Access Compliance Report

Public Rights-of-Way

Intersection ID: 5533	Main Street: FALLS_BRANCH_LN	Cross Street: MT_HOLLY-HUNTERSVILLE_RD	Location: SE
ADA ID: 5C2907061622	Ramp Type: Perp	Initial Pass/Fail: Fail	Overall Compliance: No
Codes/Mitigation Info/Possible Solution		Field Measurements/Component Compliance	
Severity Score: 13.75

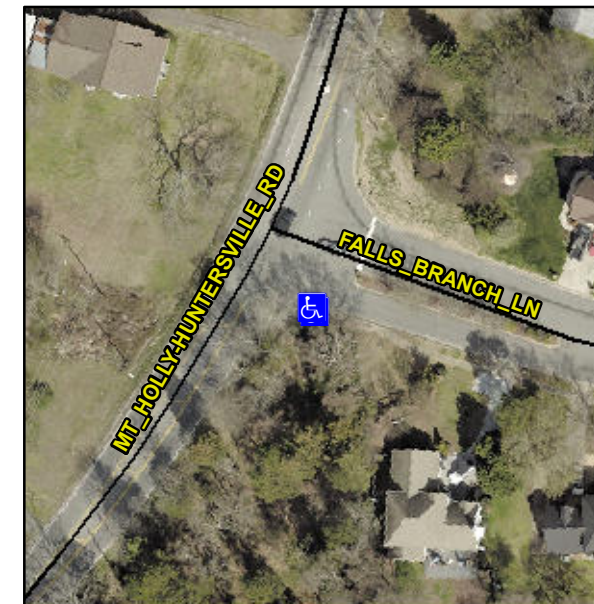
Not Found, R304.2.2, R304.5.3

Compliance	Description	Data	Compliance	Description	Data
N/A	Ramp Length (in)	48.0	No	Ramp Slope (%)	8.4
Yes	Ramp Width (in)	48.0	No	Ramp XSlope (%)	3.2
N/A	Flare Type LT	N/A	N/A	Flare Type RT	N/A
N/A	Flare Slope LT (%)	N/A	N/A	Flare Slope RT (%)	N/A
N/A	Flare Traversable LT?	N/A	N/A	Flare Traversable RT?	N/A
N/A	Landing Length (in)	N/A	N/A	DWS Provided?	N/A
N/A	Landing Width (in)	N/A	N/A	DWS Contrast?	N/A
N/A	Landing Slope (%)	N/A	N/A	DWS Length (in)	N/A
N/A	Landing X Slope (%)	N/A	N/A	DWS Full Width?	N/A
N/A	Landing Curb? (Y/N)	N/A	N/A	DWS Offset (in)	N/A
N/A	Shared Landing?	N/A			
N/A	Gutter Ponding?	N/A	N/A	Gutter Slope (%)	N/A
N/A	Gutter Lip Ht (in)	N/A	N/A	Gutter X Slope (%)	N/A
N/A	Painted X Walk1?	No	N/A	Painted X Walk2?	N/A
	X Walk 1 Direction	To NW		X Walk 2 Direction	N/A
N/A	X Walk 1 Width (in)	N/A	N/A	X Walk 2 Width (in)	N/A
	X Walk 1 Slope (%)	0.2		X Walk 2 Slope (%)	N/A
	X Walk 1 X Slope (%)	2.2		X Walk 2 X Slope (%)	N/A

N/A	Ramp inside XWalk1?	N/A	N/A	Ramp inside XWalk2?	N/A
	Road Slope (%)	2.2	N/A	Clear Space?	N/A
	Road X Slope (%)	0.2	N/A	Clear Space to XWalk (in)	N/A
N/A	Any Obstructions?	N/A	N/A	Storm Grate/Utility Hazard?	N/A
	Obstruction Type			Storm Grate/Utility Type	
		N/A			N/A
			Yes	Surface Condition? (G/P)	Good

Remove & Replace Entire Ramp.
